ADDENDUM NUMBER 4
ITB 16-ES-002 - US HWY #1 AND SR #442 FDOT LANDSCAPE BEAUTIFICATION PROJECT
CITY OF EDGEWATER

The following changes, clarification and additions are hereby made part of the **ITB 16-ES-002** - for the above **US HWY #1 AND SR #442 FDOT LANDSCAPE BEAUTIFICATION PROJECT** as fully and completely as if the same were fully set forth therein.

**Additional Questions prompted revised Landscape Plans and Bid Form which are included as a part of this addendum.**

LA 7-A

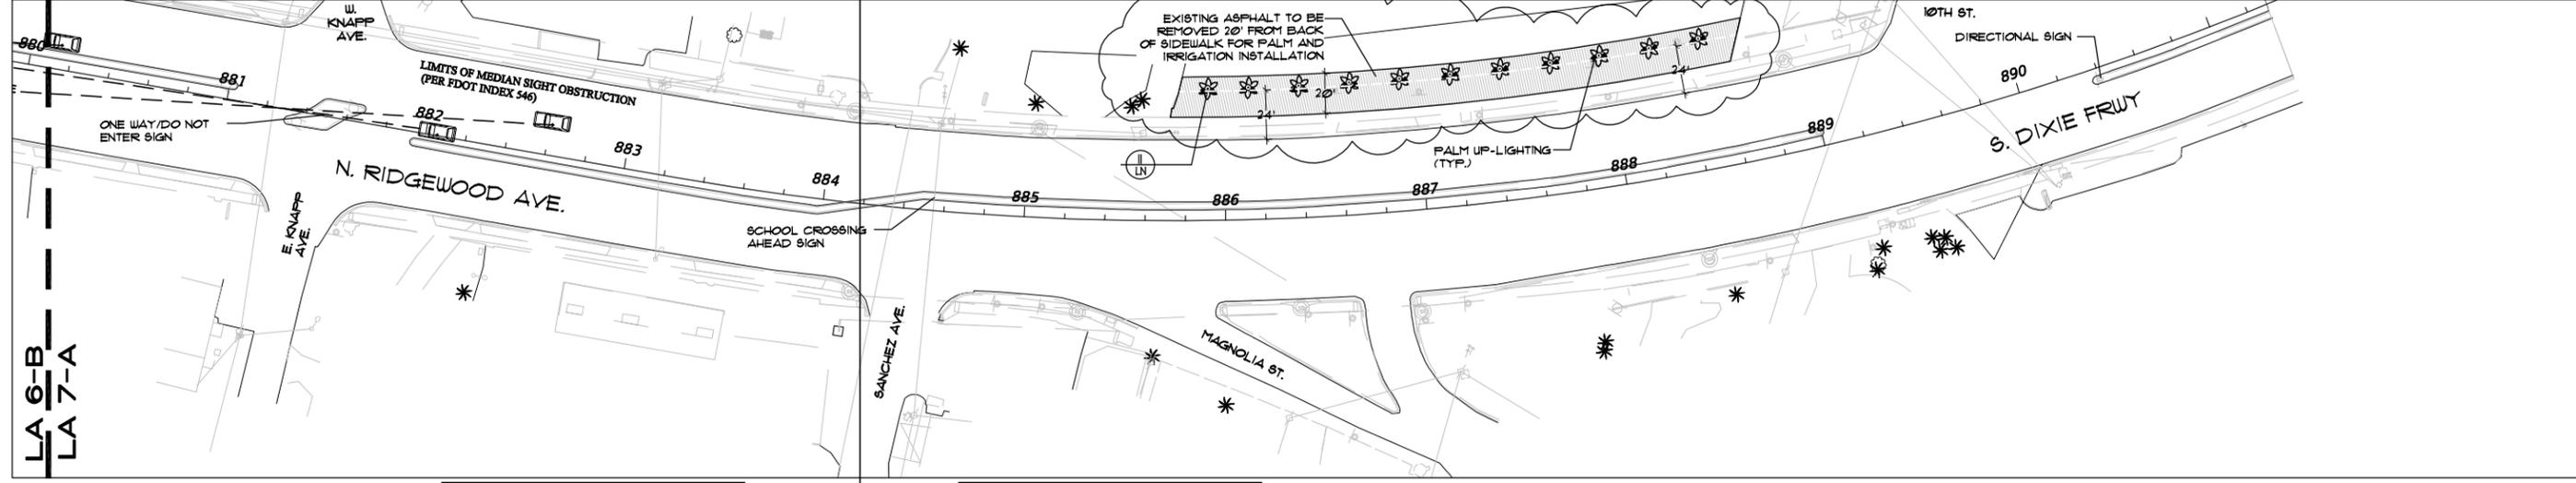
~~~~~  
Q1. After driving the work site with the new drawings, we found the trees (Carnarvon Gorge Palm) on Sheet LA7 are located in an asphalt parking lot. Do you really want these trees planted in an asphalt parking lot?
A1. This area is to be cleared of asphalt in a minimum 10 foot strip to add trees and irrigation. This item should be included in the bid item "Clearing & Grubbing".

SCALE:
SHEET IR8 OF 9

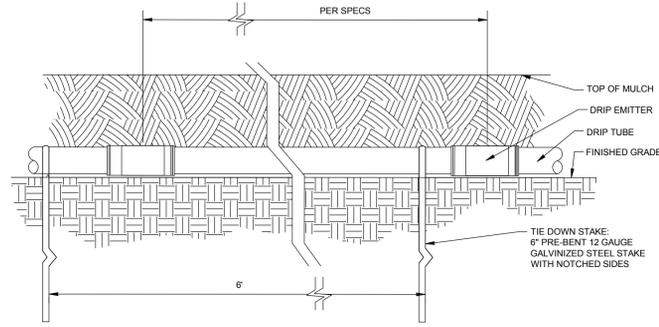
Q6. Are there really 23 wet taps into reuse mains as indicated on sheet IR 8 of 9?
A6. Comments have been addressed, see revised plans.
